APPLICATION FOR ZONING CHANGE

**OVERLAY DISTRICT  
SITE PLAN APPLICATION**

FOOD LION, INC. SITE #50a  
F.M. 740 @ F.M. 3097  
Rockwall County  
Rockwall, Texas

Preliminary Plat	
Steger Retail Addition	
James Smith Survey, Abstract No. 200	
City of Rockwall	
Rockwall County, Texas	
Client : JEMtex Development No. 50a, Inc. 1303 Walnut Hill Lane Ste. 130 Irving, Texas 75038 (214) 550-8221	Owner : Estate of O.L. Steger, Jr. & Emily Sue Whitehead C/O Lakeside National Bank P.O. Box 9 Rockwall, Texas 75087

JOB NO.	06416.01
DATE	2-18-91
DRAWN	A.J.L./A.L.C.
CHK.	M.D.C.
DISC.	6416Site.Dwg
SHEET OF	1 of 1
LANDSCAPE PLAN

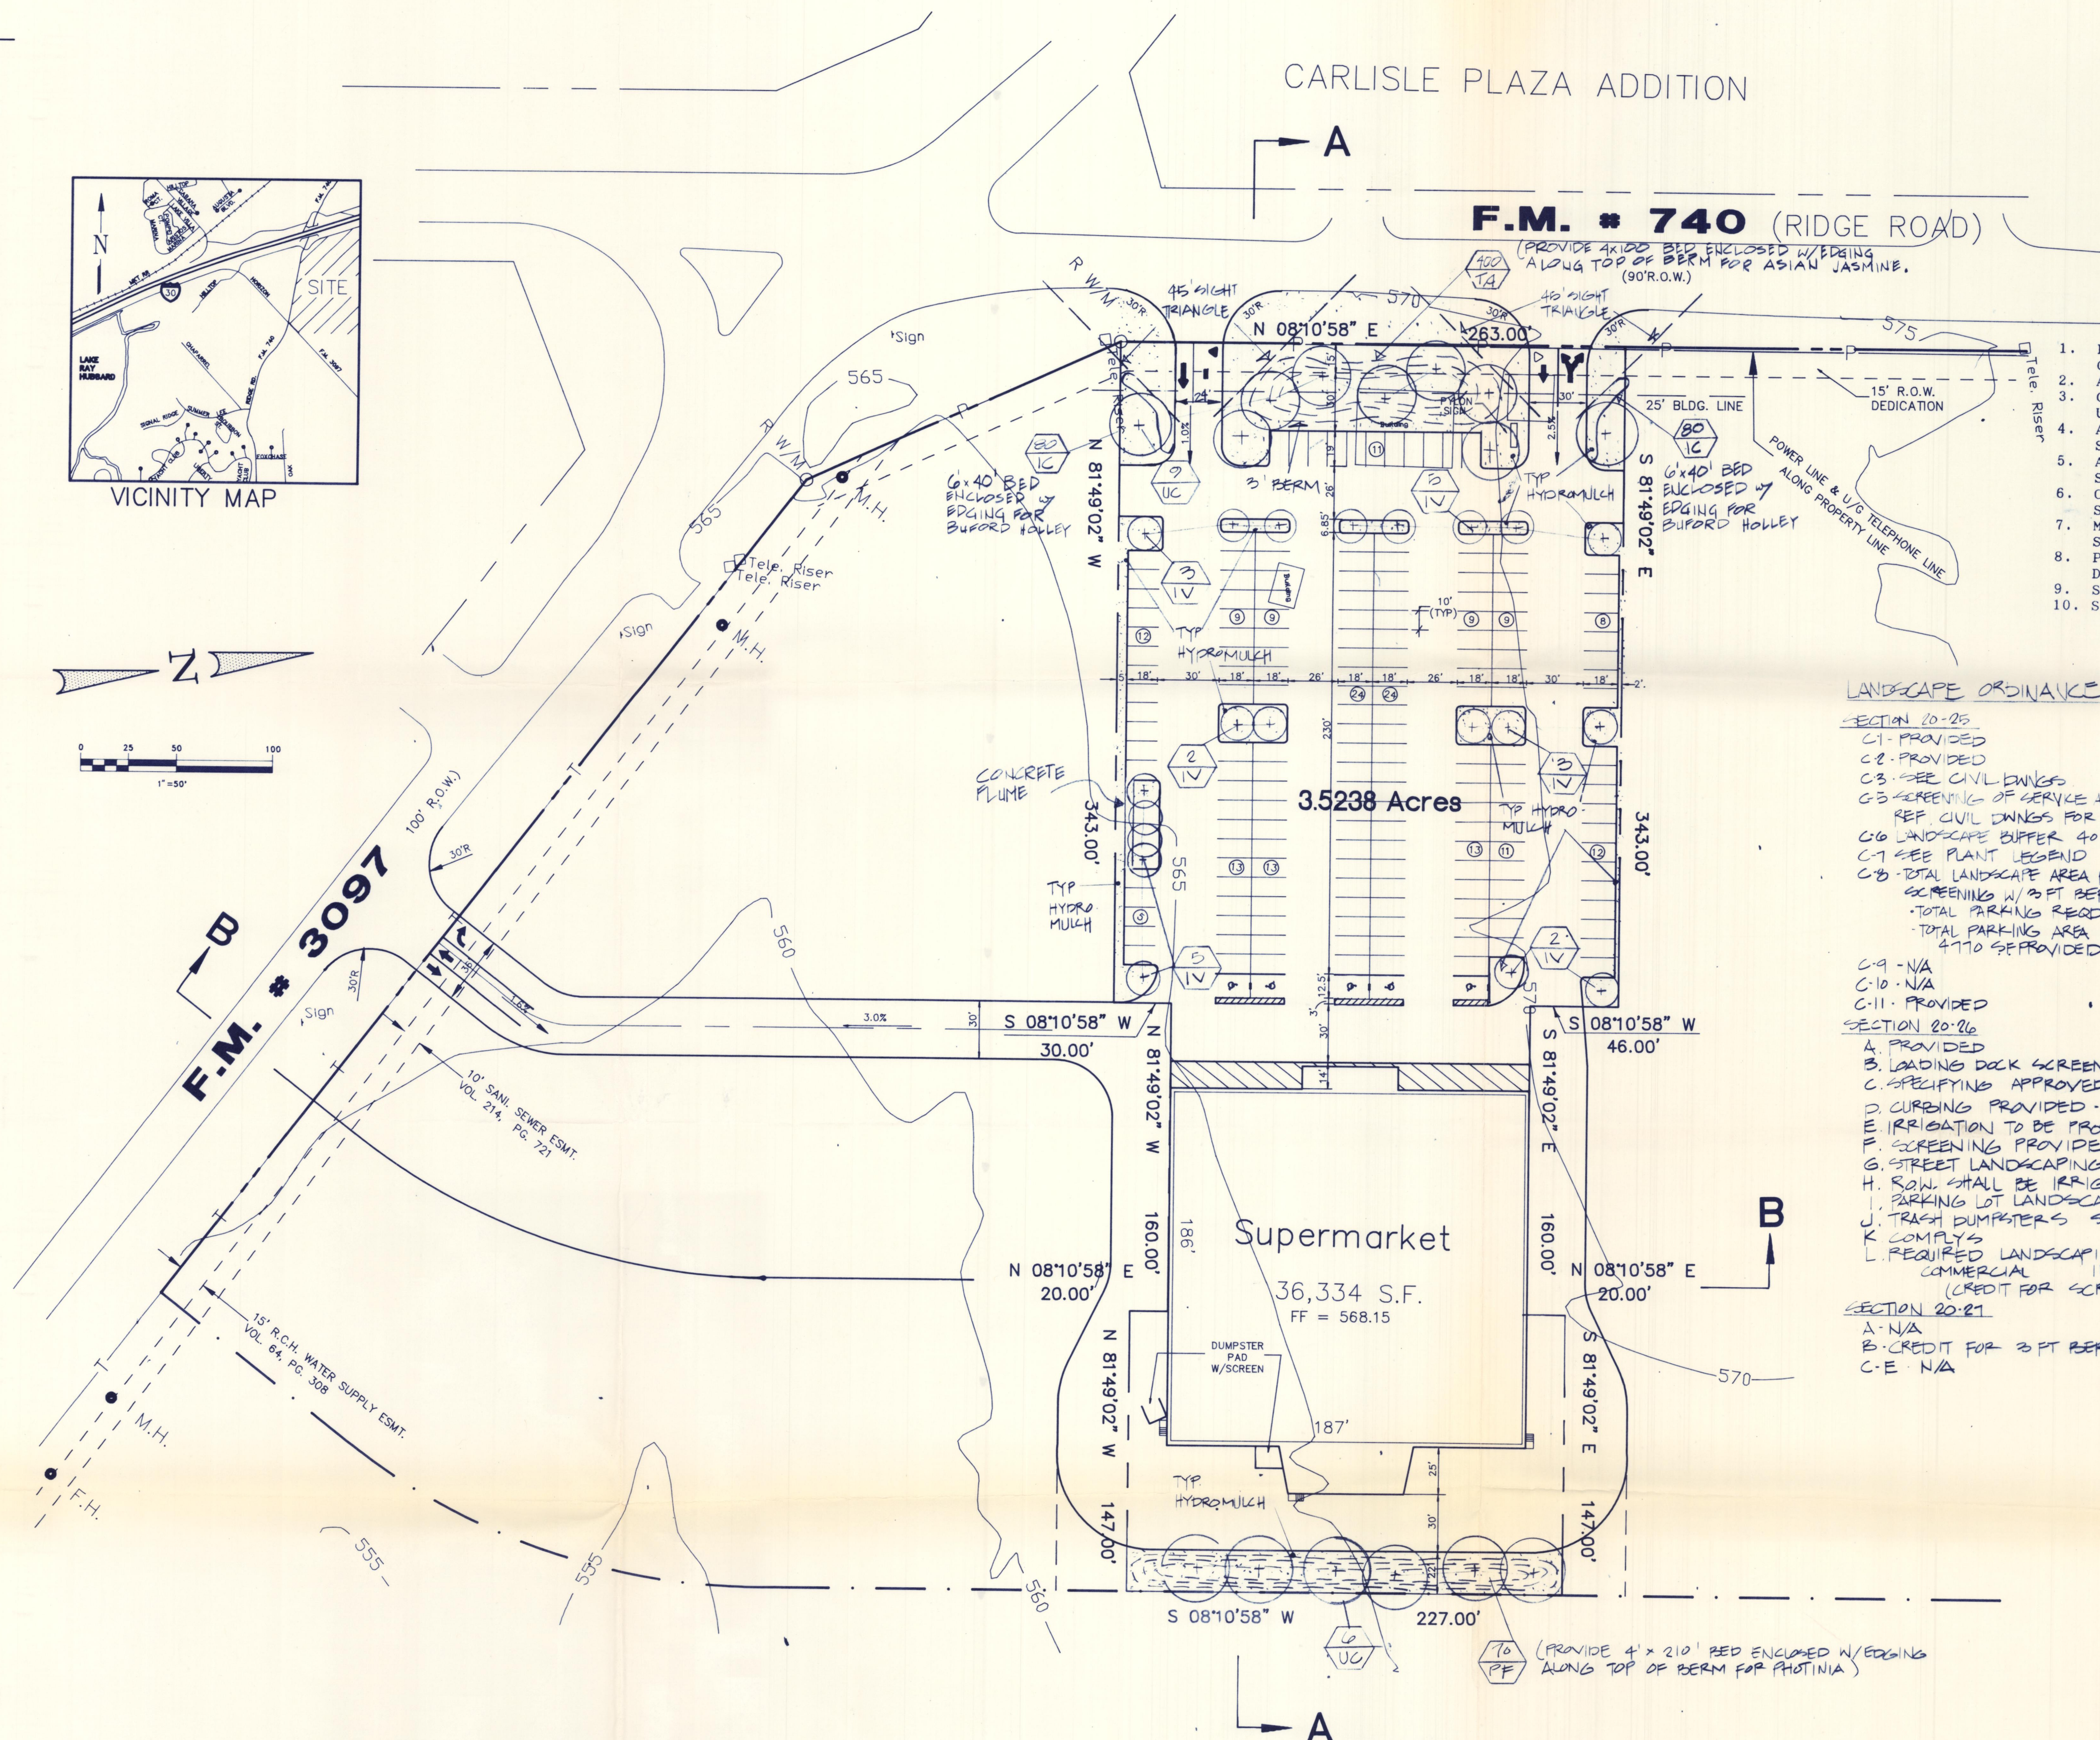
Get strip of landscaping down middle of get credit - add  
 drive are too close per requirements large  
 need shrubs on either side of drive trees in  
 install a canopy in front of bldg. center &  
 change all to large trees

parking lot area  
 73, 660 =  
 5% 3,630  
 discuss easement going to be paved?  
 check usability triangles? why so big  
 discuss internal landscaping in parking lot  
 would normally need a large tree - have 17 small trees  
 need to add 2 more trees in street  
 I don't get required landscaping - only 16,638 \$

1. The total site requirement for landscaping is 18,708 sq. ft. In reviewing the plan I find approximately 16,600 sq. ft. Please identify the area of the individual landscaped areas. The area to be dedicated as ROW for FM-740 cannot be included in the calculation. I would recommend that you consider including an 8 foot strip between the two center parking stalls. This would provide the additional landscaping area and would enhance the parking lot.
2. You have reduced the percentage of required landscaping by including a 3 ft. berm in the front of the tract. Please identify what landscaping will be planted on

the berm in addition to the required street trees. I would encourage some low maintenance ground cover or low shrubs along the top of the berm. You will need to add 3 foot evergreen shrubs in front of the parking lot on either side of each entrance to fully gain this credit.

4. You need to add 2 more trees along the frontage. In the Overlay District the ratio is one tree per each 30 feet of frontage.
5. You are showing 17 yaupon holly trees internal to the parking lot. These are classified as small trees under our landscaping ordinance. The ordinance provides that one large tree per every 20 parking spaces be provided. This may be considered an equivalent exchange by the Commission, which will be discussion at the meeting.

1. Winkelmann & Associates, Inc.'s calculations indicate a total of 17,642 square feet of landscape area on the plan as originally submitted. We have eliminated an unnecessary drive to "pick up" 600 S.F. and modified a radius to lose on parking space to "pick up" 180 S.F. and narrowed one drive to "pick up" 360 s.f to provide a total of 18,782 S.F.
- 2 & 4. Modifications have been made in accordance with comments.
5. Information only.

JOB NO.	06416.01
DATE	2-18-91
DRAWN	A.J.L./A.L.C.
CHK.	M.D.C.
DISC.	6416Site.Dwg
SHEET OF	1 of 1
SITE PLAN

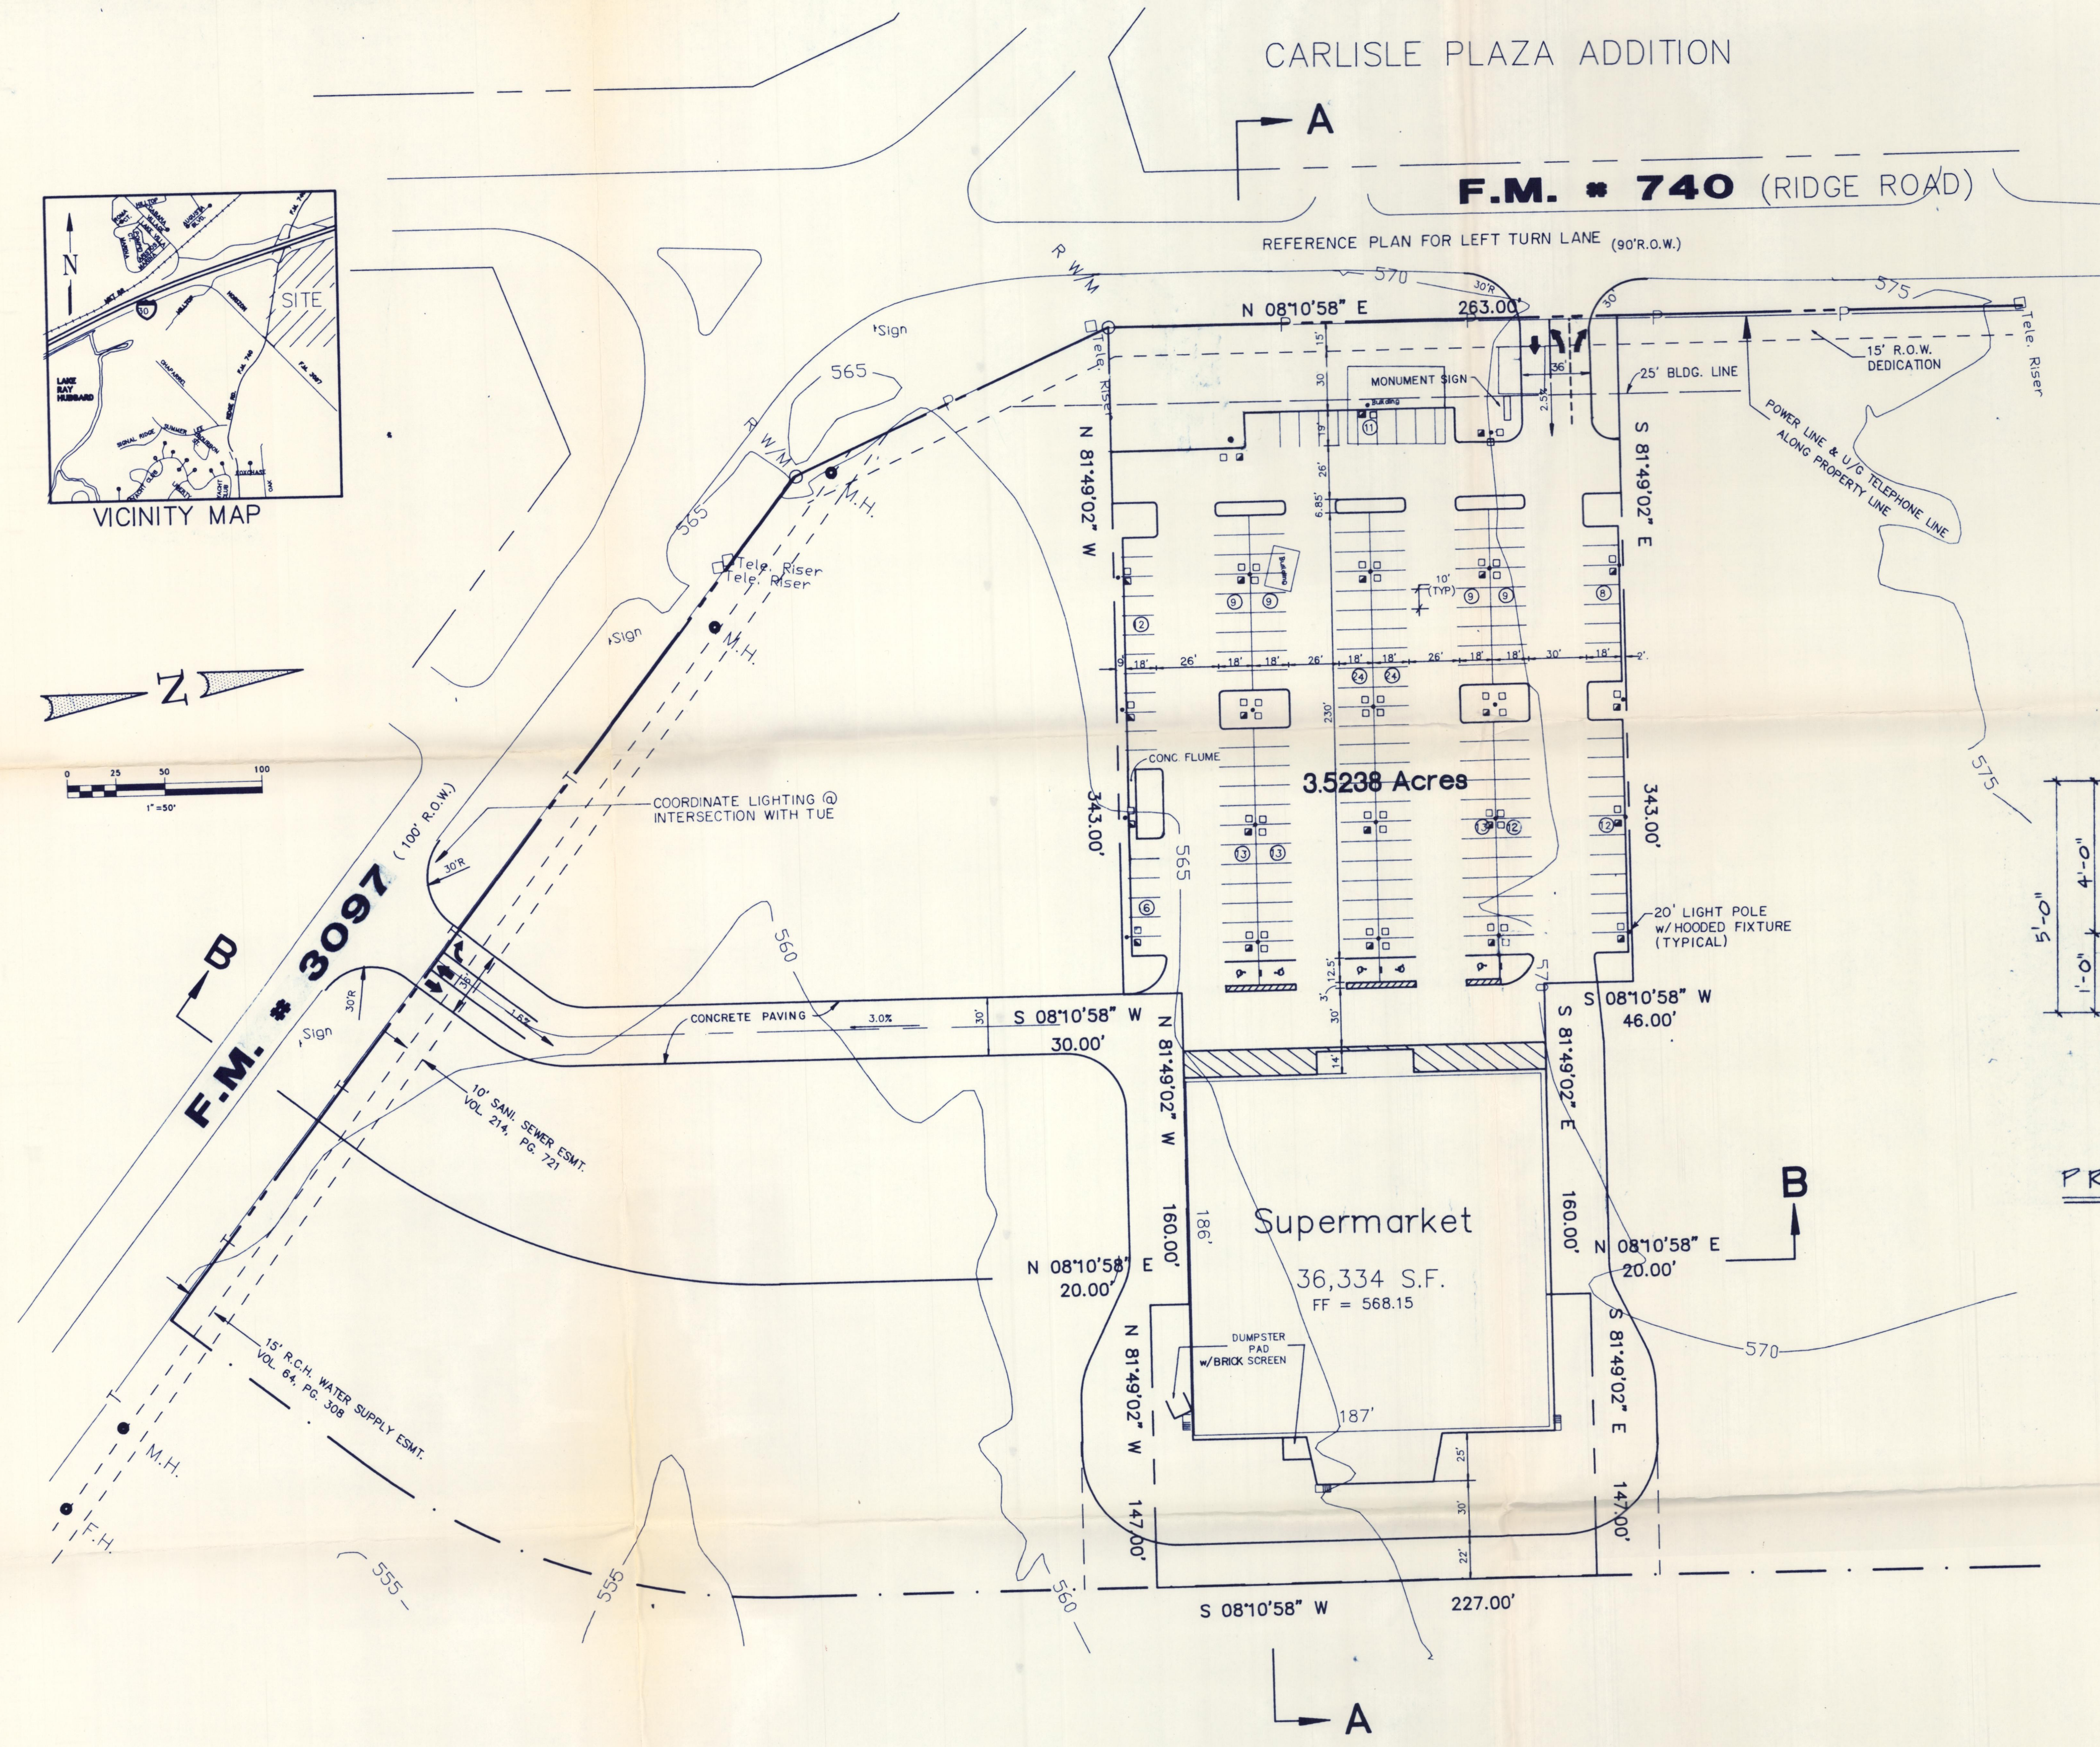
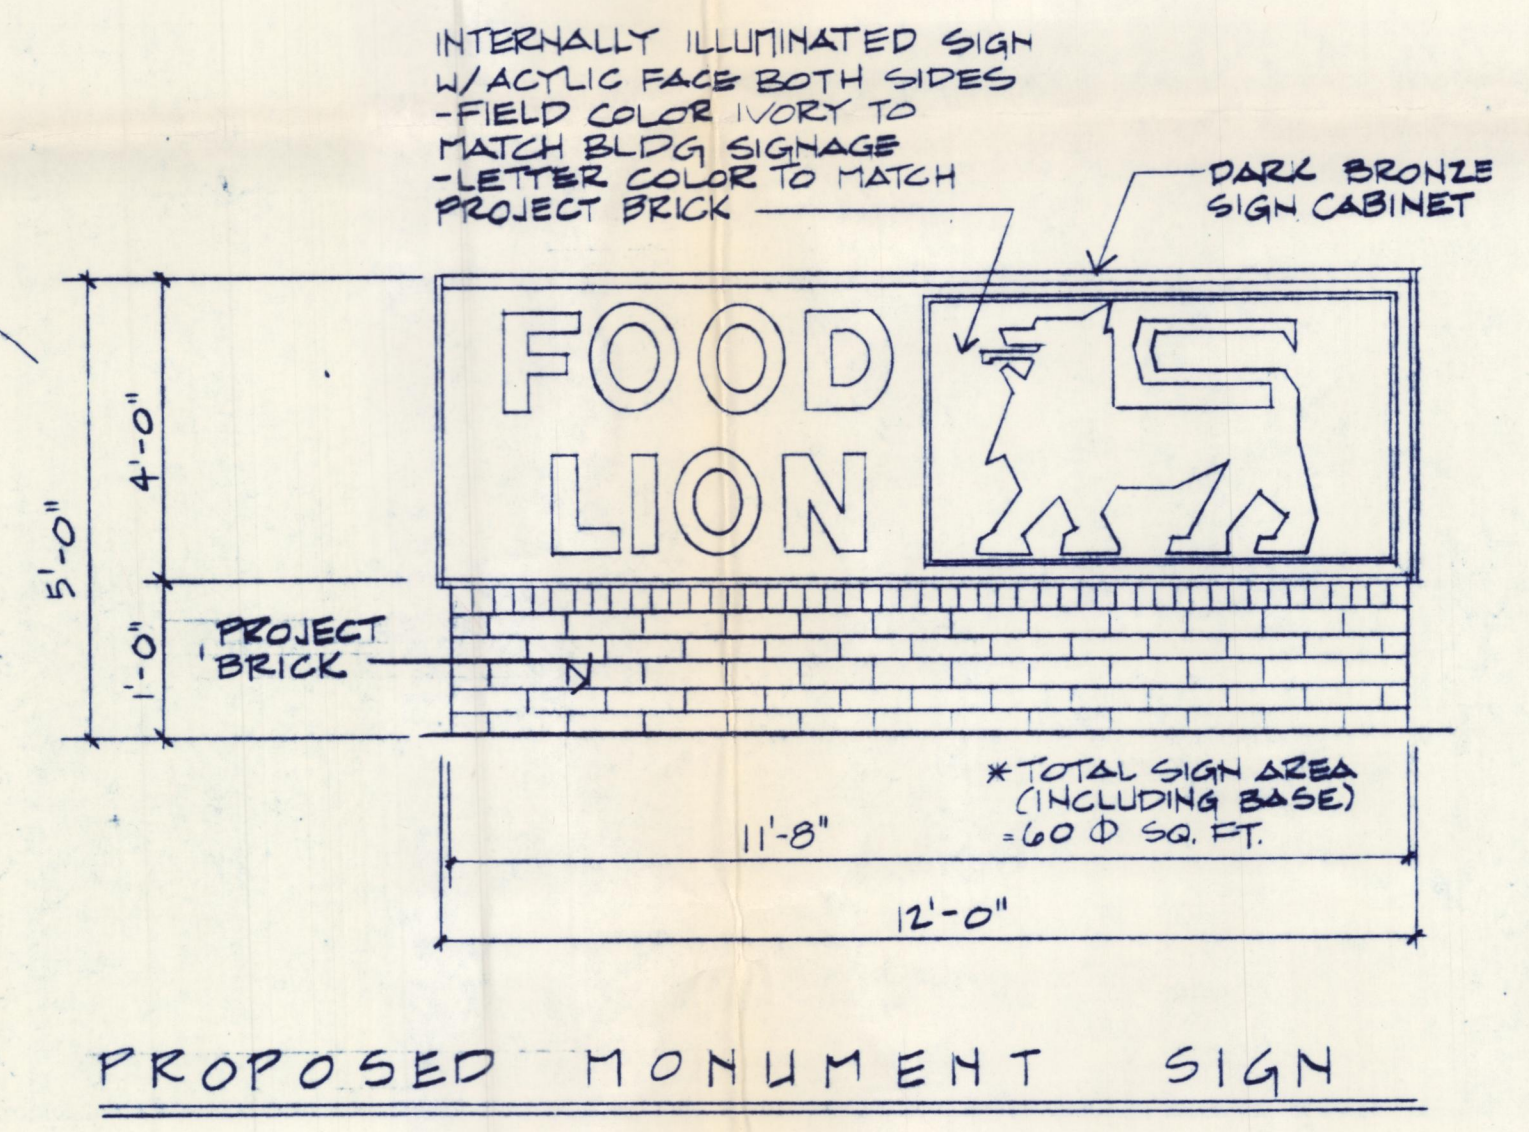
need to show drive lane expansion on site plan.

1. The plan proposes two drives on FM-740 that are approximately 160 feet apart. The minimum separation for drives along an arterial is 200 feet. The Commission

and Council have the ability to waive this requirement if it is determined to be in the interest of the City. The Commission and staff have some concern about the proximity of the southern drive to FM-3097. Given this concern and the fact that the drives do not meet separation standards you will need to either amend the plan to eliminate the southern drive or present your reasons for wanting the two drives. The original plan proposed for Food Lion to the south of this location did not propose two drives on FM-740.

3. There was some concern about the throat length of the entrance(s). I am having John Reglin review this issue.
4. As you are aware a turn lane does need to be provided for the entrance off of FM-740. From preliminary discussions with Mr. Reglin it appears that the existing turn lane for the shopping center can be added onto to meet the needs of your turn lane. You need to submit a schematic of what you propose to do to address the turn lane.

5. You need to submit details for the parking lot lighting. The previous site plan was restricted to light poles not exceeding 20 feet in height with hooded fixtures to direct the glare. Please indicate the type and height of lighting proposed.

1. All easements have been added to this drawing.
2. A future 10' R.O.W. dedication has been shown for FM 3097.
3. As discussed, we have modified the R.O.W. on the major thoroughfare to be 110' wide.
- \* 4. Driveway locations have been noted.
- \* 5. A note stating that a reciprocal easement agreement will be established for Lots 1, 2 & 3 has been added.

PICK-UP DETAIL

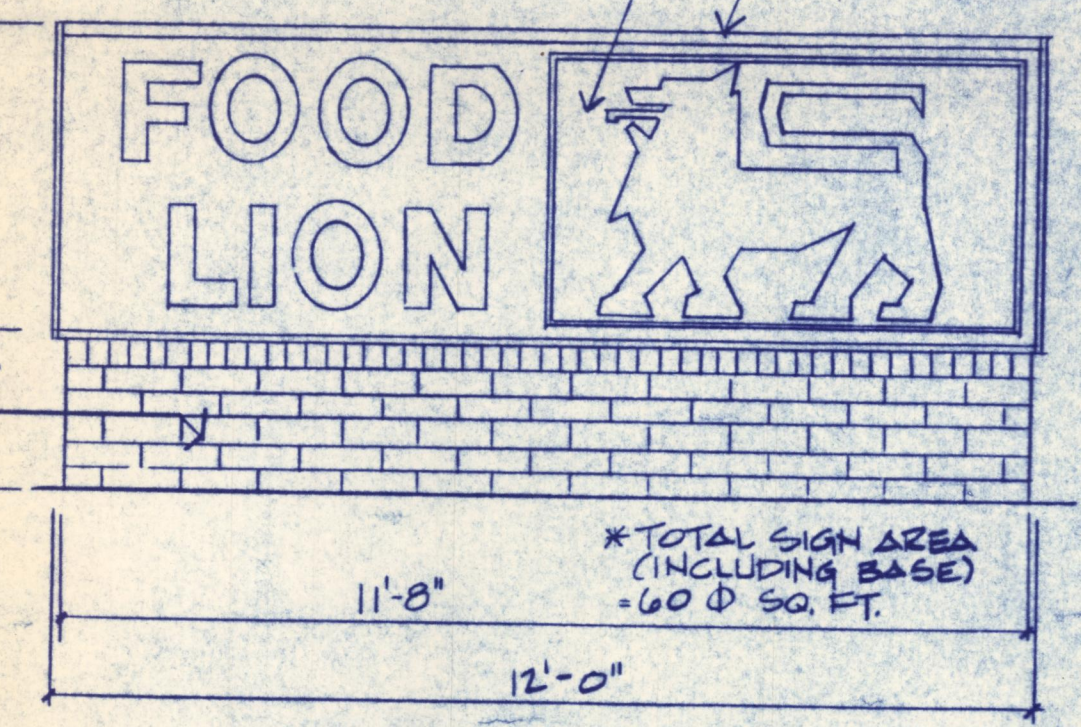
*Approved copy*  
*need to change landscaping*
